**Plan Commission Staff Report  
Department of Planning and Building  
Town of McCordsville**

**January 19, 2021**

**Project:** McCord Pointe, Section 7

**Request:** Petitioner is seeking approval of the Development Plan and Secondary Plat for Section 7

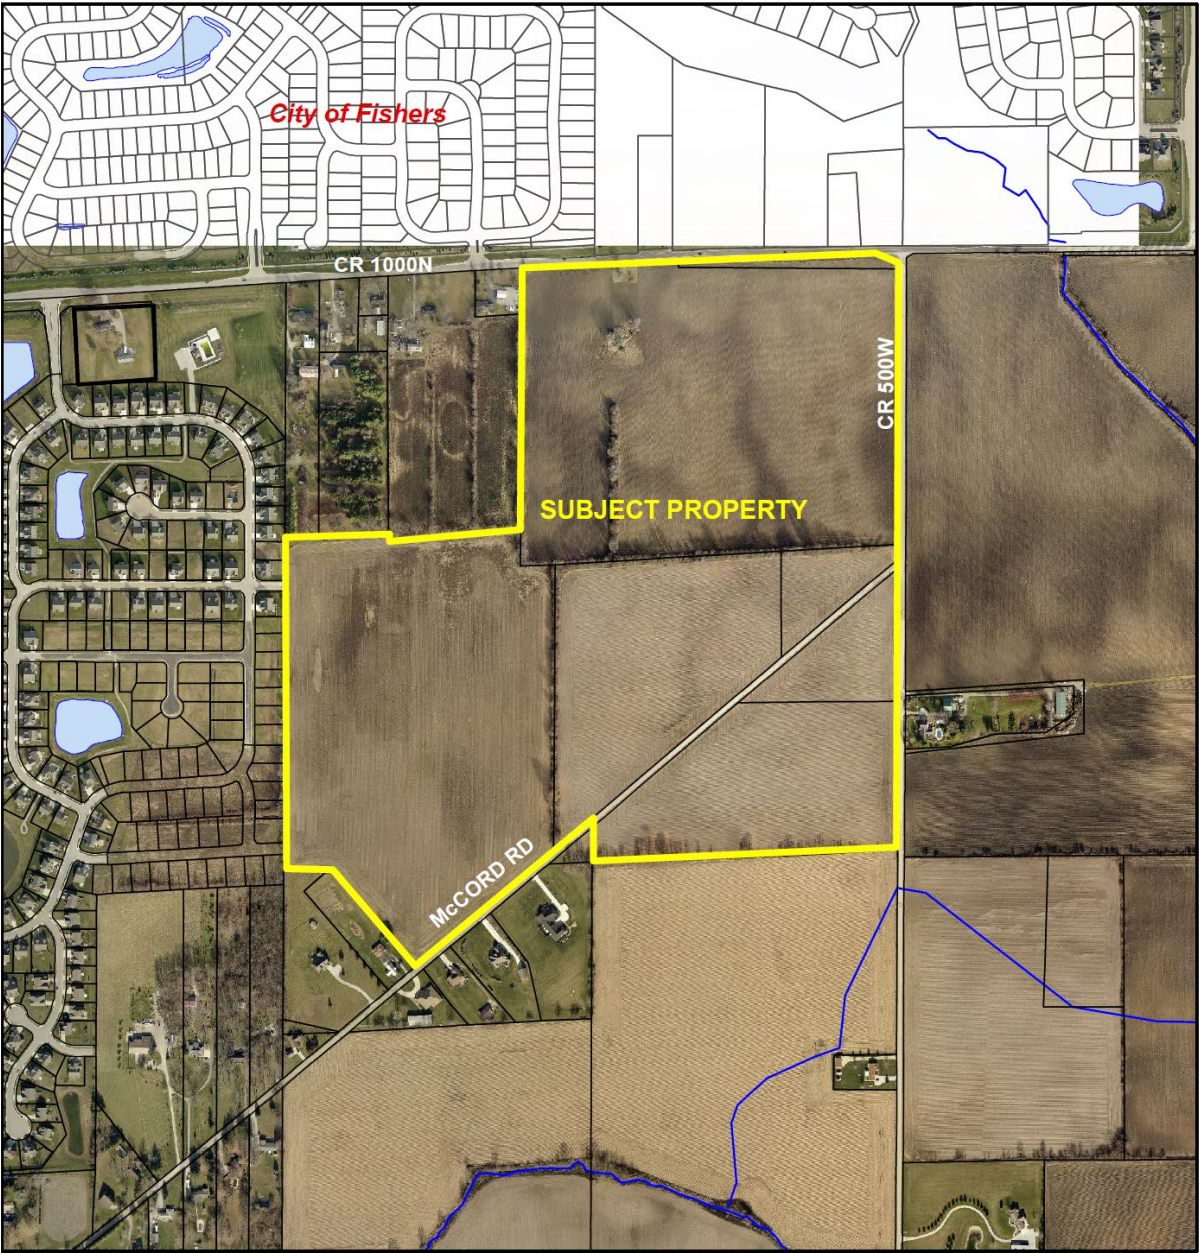
Staff is concerned by the fact that there are no plantings proposed for the median.

*Signage:* The primary and secondary monument signage does not appear to be denoted on the plans.

*Interior Sidewalks:* Staff has a concern over the lack of ADA ramps around the proposed round-a-bout.

*McCord Road Round-a-bout:* Staff would like to see further discussion on the round-a-bout's apron size and the type of stamp/stain that will be applied.
